PCN Report

Prepared By : Maggie Xu, Thyristor Product Engineer
Date : February 7th, 2018
Products : Thyristor Products acquired from ON Semiconductor
Revision : A

This report covers manufacturing site transfer activities of Thyristor products acquired from ON Semiconductor. Site transfer includes backend assembly, final test and packaging operations.

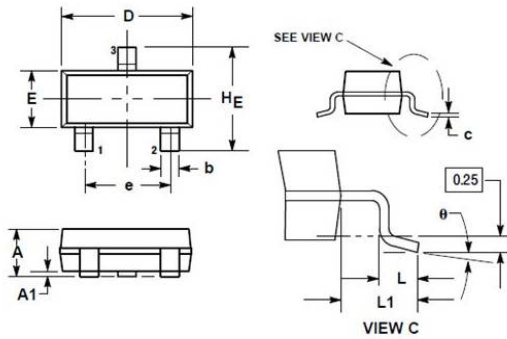
Format of Date code section of component marking is changed as follows.

PACKAGE	Date Code Format by ON Semiconductor (Old)	Date Code Format by Littelfuse (New)	Symbols
SOT23	M	YMA	Y: Year of Manufacturing M: Month of Manufacturing WW: Week of manufacturing A: Assembly location XX: Lot serial code
SOT223	AYW	YMA	
TO-225AA	YWW	YMAXX	
TO-251	YWW	YMAXX	
TO-252	YWW	YMAXX	
TO-220 Iso	AYWW	YMAXX	
TO-220AB	AYWW	YMAXX

4.2 SOT223 Outline

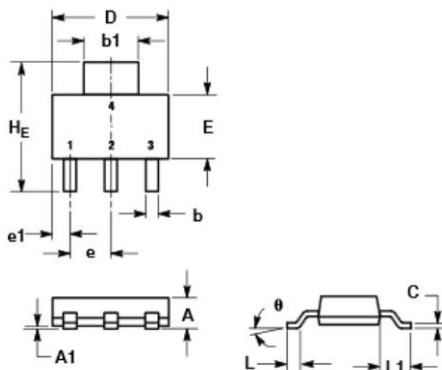
---Dimensions A, A1, c, D, e1 are different.

DIM	ON Semi Specification			Littelfuse Specification (New)		
	MILLIMETERS			MILLIMETERS		
	MIN	NOM	MAX	MIN	NOM	MAX
A	1.50	1.63	1.75	-	-	1.80
A1	0.02	0.60	0.10	0.02	0.07	0.13
b	0.60	0.75	0.89	0.66	0.75	0.84
b1	2.90	3.06	3.20	2.90	3.00	3.10
c	0.24	0.29	0.35	0.23	0.29	0.35
D	6.30	6.50	6.70	6.60	6.60	6.71
E	3.30	3.50	3.70	3.30	3.50	3.70
e	2.20	2.30	2.40	2.30 BSC		
e1	0.85	0.94	1.05	0.75	0.95	1.15
L1	1.50	1.75	2.00	1.50	1.75	2.00
He	6.70	7.00	7.30	6.80	7.00	7.20
∅	0°	-	10°	0°	-	10°
